Anthropomorphic Test Devices; Hybrid III 6-Year-Old Child Test Dummy

ACTION: Notice of proposed rulemaking (NPRM).

SUMMARY: Today's NPRM proposes two changes to the agency's specifications for the Hybrid III six-year-old child dummy. In Part 1 of this NPRM, to improve the durability of the dummy's femurs, we propose changes to the design of and material used for the femur assembly. In Part 2, the drawing for the abdomen insert would be corrected so that the abdominal insert dimensions on the drawing reflect the actual part. Part 2 of this rulemaking commenced in response to a petition for rulemaking submitted by Denton ATD (Denton) and First Technology Safety Systems (FTSS). This document declines the petitioners' suggestion to investigate tolerances for vinyl and rubber components of the dummy and to specify the expected time frame each part would meet the tolerances.

Figure 1: Illustration of femur assembly

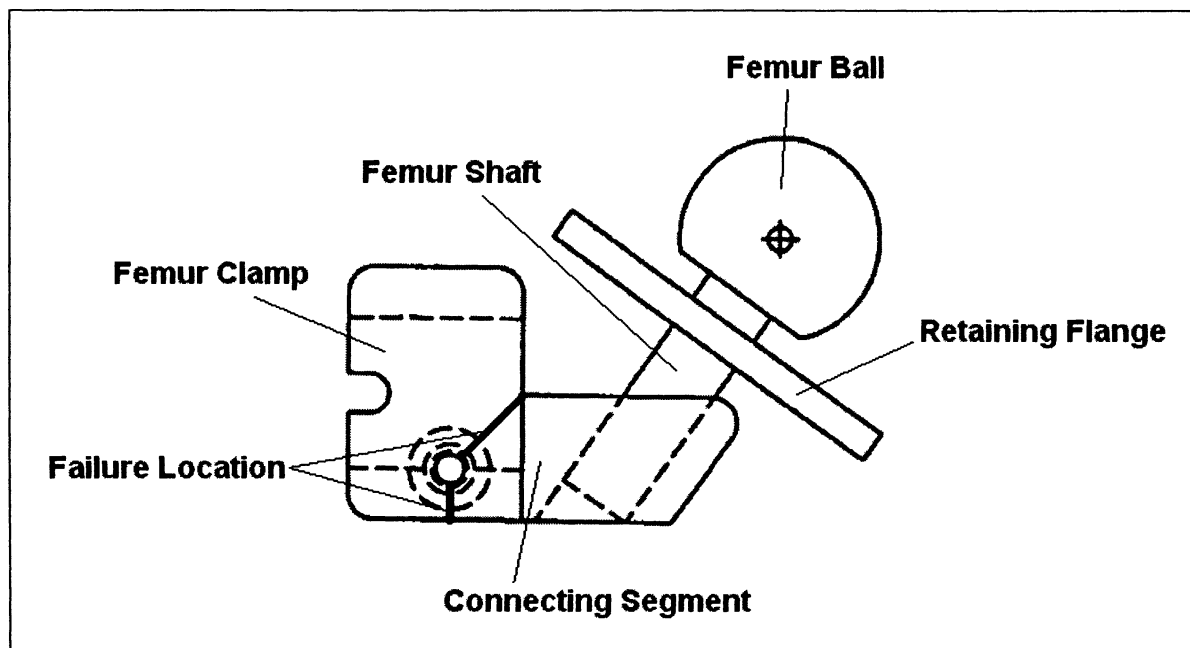
illustration shows the approximate location of the femur failure. (The femur load cell, the response of which is discussed in the “dynamic evaluation” section below, is located in the distal portion of the upper leg (i.e., farther from the pelvis) and not in the area of the machined femur.)

Failures of the HIII–6C femur appear to have initiated at a sharp corner between the femur clamp and connecting segment sections of the machined femur. The fracture was observed from this corner to the bolt hole within the femur clamp, at an angle of approximately 45°. The failure continued through the thin section of material directly beneath the bolt hole, causing complete separation of the machined femur. Additionally, in one failed component, small indents on the inner diameter of the retaining flange were observed, indicating potential contact between the flange and shaft. The location of the fracture is depicted in the Figure 1 illustration. Pictures of

The proposed modification to improve the femur’s durability is based on the approach developed by FTSS. The agency decided on that approach over Denton’s because the FTSS design was more straightforward and simpler than that of Denton,⁶ and a similar design change had demonstrated improvement in the HIII–10C. Rather than re-designing, FTSS increased the strength and durability of the femur assembly by fabricating the machined femur and shaft from 4340 steel, which has a higher yield strength than the

original material, aluminum bronze C–624 AMC0–18, while keeping the ball and retaining flange as the original aluminum bronze material. A ¼-inch (6.35 mm) circular fillet was added between the femur clamp and the connecting segment to eliminate stress-risers that were present on the original femur, and a portion of the connecting segment material near the femur clamp was removed. The weight of the new FTSS femur is only 0.002 lb (0.001 kilograms (kg)) heavier than the original femur. Table 1 below compares the weights and material properties of the original femur, the FTSS-developed femur, and the Denton-developed femur.

To implement this change in femur design and material, the following changes would be made to the materials describing the HIII-6C in 49 CFR Part 572. Drawings 127-3017-1&-2, “6 YR H3—FEMUR MACHINED” would be replaced with drawings 127-3017-1S&-2S, which show the proposed machined femur.⁷ The femur assembly drawings (127-3016-1&-2) would also be changed due to the new femur design, with new part numbers 127-3016-1S&-2S. Higher assembly drawings including 127-3000, “LOWER TORSO ASSEMBLY,” and the complete assembly drawings (127-0000) would be amended to show the proposed part. These revisions would be noted on drawing SA572-127DRL-2. The PADI would also be updated so that it shows the proposed machined femur in figures and reports the proper lower torso assembly and total weight for the dummy. Finally, the part numbers for the machined femur and the femur assembly would be changed in the Parts/Drawings list, along with the revision letters for higher assembly drawings, as appropriate. Copies of the HIII-6C drawing package, PADI, and Parts/Drawings list that include the proposed change in femur design can be obtained online at <http://www.regulations.gov>, in the same docket as this NPRM.

Figure 7: Portions of the HIII-6C Abdomen Insert drawing

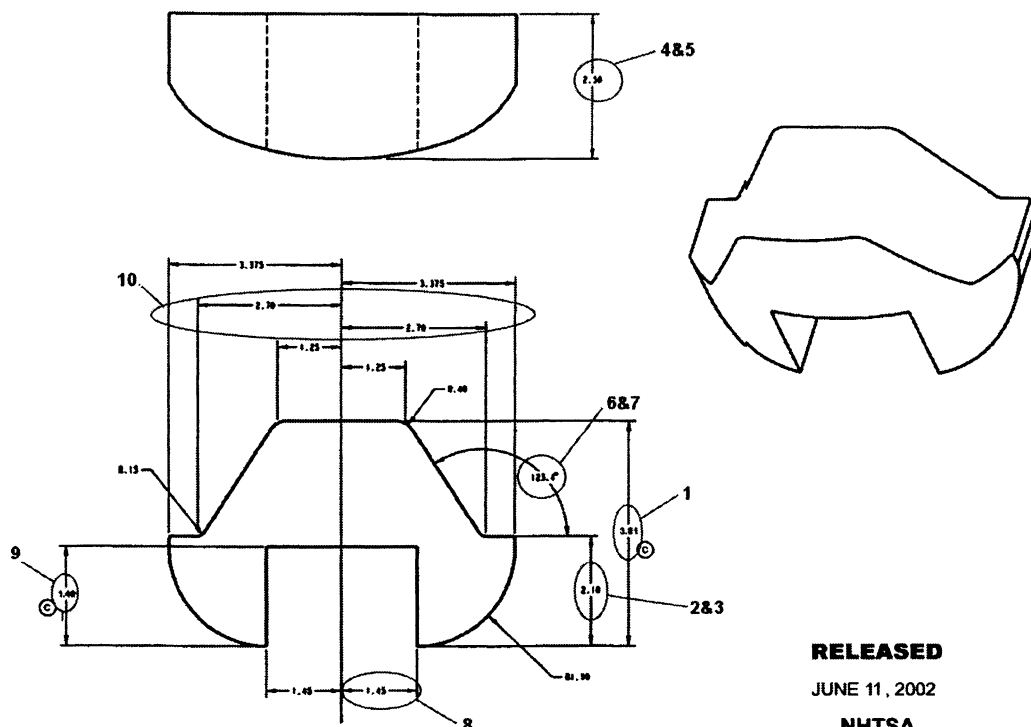
FTSS and Denton petitioned NHTSA to change Drawing No. 127–8210 of the HIII–6C drawing package, which specifies the abdominal insert for the dummy. The petitioners stated that FTSS owns the original mold for the abdominal insert that was part of the dummies used by NHTSA to develop the 49 CFR Part 572 specifications for the dummy, and that the mold is still being used to manufacture the HIII–6C dummies. The petitioners stated that they have measured the mold to compare its dimensions to those of the drawing and have “a number of discrepancies between the mold and the drawing.” The petitioners stated that Denton has also measured its abdominal insert mold, and has found it to match the FTSS mold dimensions. Both

manufacturers stated their belief that Drawing No. 127–8210 is in error because of these discrepancies, and have asked NHTSA to revise the abdomen insert drawing to match the part mold dimensions. The petitioners submitted a revised drawing as part of their petition for rulemaking which provided new dimensions for the ledge height, depth, and taper angle of cone.

We tentatively agree with the petitioners that several dimensions of the abdomen should be revised. Although the recommended dimensional changes are mostly based on agency measurements of physical parts, nearly all changes are in agreement with the petitioners' mold-based dimensions. The recommended action would incorporate the petitioner-recommended changes in dimension to the ledge height and overall depth. The taper angle of the cone dimension would also be changed to include the range of angle requested by the petitioner, but have a nominal value of 125° rather than 122.4° , and an increased tolerance of $\pm 4^\circ$ to account for the range of angles measured in the available parts.

However, there are two small dimensional discrepancies between the part and drawing that were not addressed in the petition: The notch half width and notch depth dimensions. We are adjusting the notch half width dimension based on measurements of abdominal inserts at VRTC. The notch half width measurements were all larger than the specified nominal dimension of 1.45 inches, and one measurement fell outside the allowed tolerance. Therefore, a slight increase in this dimension to 1.50 inches is proposed. The suggested changes to the abdominal insert drawing are reflected in Table 4

under “Proposed Spec.” We have decided not to adjust the notch depth dimension based on part measurements, because only one out of five measurements did not meet the specification, and the age of this part may have affected this dimension. This decision is discussed more fully in the technical report.
